Consumers
Power
Company

January 10, 1969

Re: Docket 50-155
DPR-6 ZEK

As a follow-up to conversations with your staff, we are sending you information on the mechanical design and manufacturing changes of a single Reload "E" fuel bundle (designated W-1) which will be inserted into the Big Rock Point reactor during our next refueling outage in early 1969. The fuel bundle is being fabricated by a vendor other than our previous fuel supplier. However, it has been designed and manufactured to the same criteria as the Reload "E" fuel and as such does not, in the opinion of Consumers Power Company, involve an unreviewed safety question or a change to the Technical Specifications of License DPR-6, Docket No 50-155, issued to Consumers Power Company on May 1, 1964, for the Big Rock Point Nuclear Plant.

COBALT FLOW NOTES ADDED	5.13	RM
CHANGES	5.13	RM
 Canadian Westinghouse Company Limited ATOMIC FUEL DEPARTMENT PORT HOPE, ONTARIO		
BIG ROCK POINT FUEL BUNDLE - W-1		
SHEET 1 OF 1 SHEETS	BASIC	REV 10
	B	3524
DRAWING AND PART NUMBER		CONF

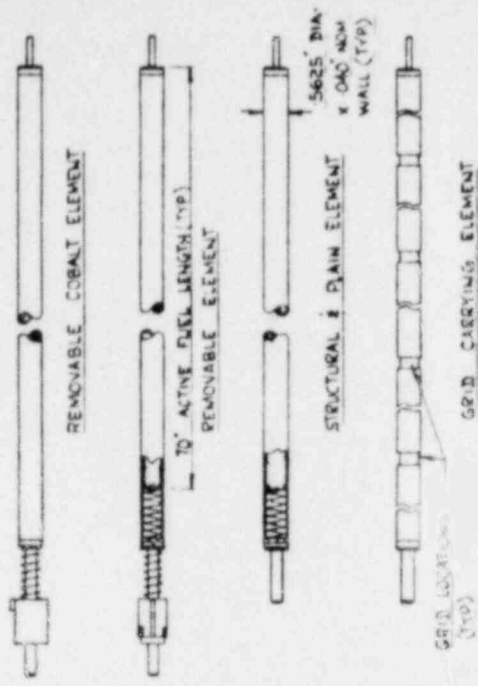
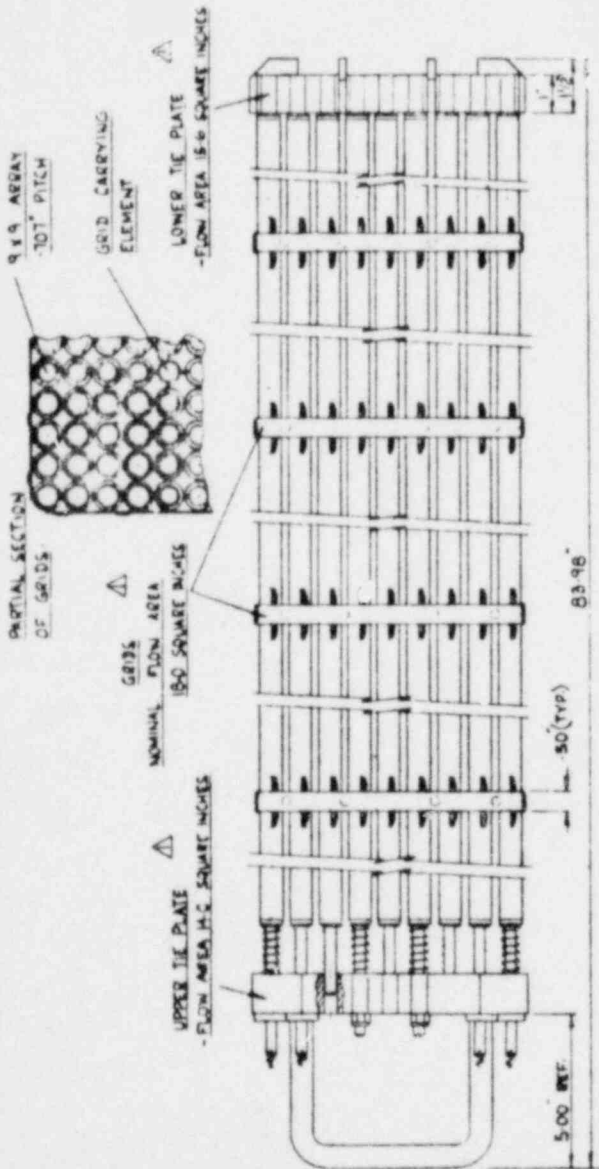
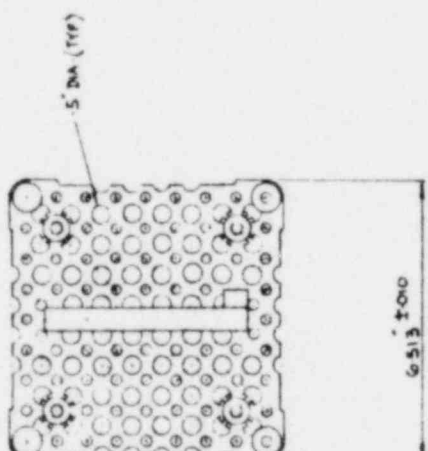
The mechanical design (see drawing attached) and fabrication of this Reload "E" Fuel Bundle W-1 was provided by Canadian Westinghouse and, hence, is slightly different from the other Reload "E" bundles in the following respect:

A combination of brazed wear pads and positioning grids at four locations along the bundle length is used to support the fuel rods. This concept has arisen from the basic manufacturing and operating experience of Canadian Westinghouse Company, Ltd. Although it is somewhat different from the United States spring spacer concept, it has proven successful in the Canadian nuclear power program. We expect that it will prove equally successful in our application.

The physics design of Reload Bundle W-1 is exactly equivalent to the other Reload "E" bundles. However, the fuel enrichment

has been decreased slightly to compensate for a slightly increased fuel rod stack density. The bundle power distribution and all other physics characteristics of Bundle W-1 are exactly the same as the Reload "E" fuel; and the flow analysis shows a slight increase in coolant flow arising from improved geometry characteristics of the W-1 bundle.
